Access Compliance Report

Public Rights-of-Way

Intersection ID: 47449	Main Street: MALLARD_LANDING_RD	Cross Street: WOOD_DUCK_CROSSING_DR	Location: SW
ADA ID: C7D19B9635C3	Ramp Type: PerpDiag	Initial Pass/Fail: Pass	Overall Compliance: No
Severity Score: 0			
Codes/Mitigation Info/Possible Solution		Field Measurements/Component Compliance

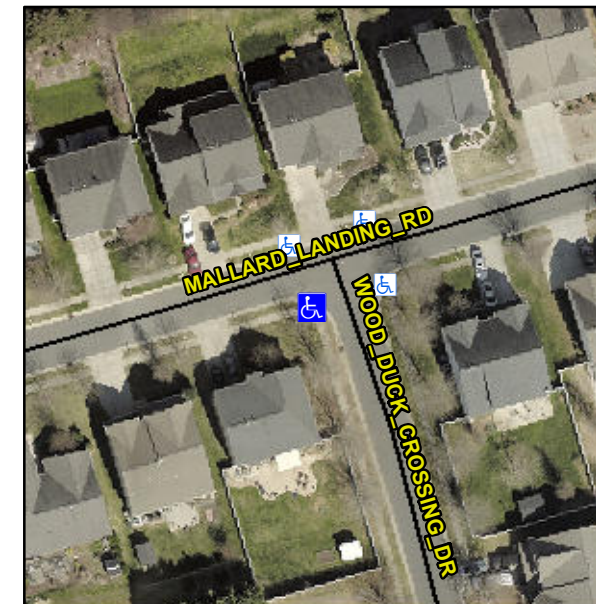
R304.2.1, R304.2.2-Perp, R304.3.2-Para, R304.5.3

Compliance	Description	Data	Compliance	Description	Data
N/A	Ramp Length (in)	46.0	Yes	Ramp Slope (%)	5.5
Yes	Ramp Width (in)	49.0	Yes	Ramp XSlope (%)	1.9
N/A	Flare Type LT	Sloped	N/A	Flare Type RT	N/A
N/A	Flare Slope LT (%)	0.5	Yes	Flare Slope RT (%)	5.6
N/A	Flare Traversable LT?	Yes	N/A	Flare Traversable RT?	Yes
No	Landing Length (in)	46.5	Yes	DWS Provided?	Yes
Yes	Landing Width (in)	48.0	Yes	DWS Contrast?	Yes
No	Landing Slope (%)	5.4	Yes	DWS Length (in)	24.0
No	Landing X Slope (%)	4.3	Yes	DWS Full Width?	Yes
N/A	Landing Curb? (Y/N)	No	Yes	DWS Offset (in)	0.0
N/A	Shared Landing?	No			
Yes	Gutter Ponding?	No	Yes	Gutter Slope (%)	0.7
Yes	Gutter Lip Ht (in)	0.0	Yes	Gutter X Slope (%)	2.0
N/A	Painted X Walk1?	No	N/A	Painted X Walk2?	No
	X Walk 1 Direction	To E		X Walk 2 Direction	To N
N/A	X Walk 1 Width (in)	N/A	N/A	X Walk 2 Width (in)	N/A
	X Walk 1 Slope (%)	0.6		X Walk 2 Slope (%)	2.0
	X Walk 1 X Slope (%)	3.7		X Walk 2 X Slope (%)	1.3

Remove & Replace Landing.
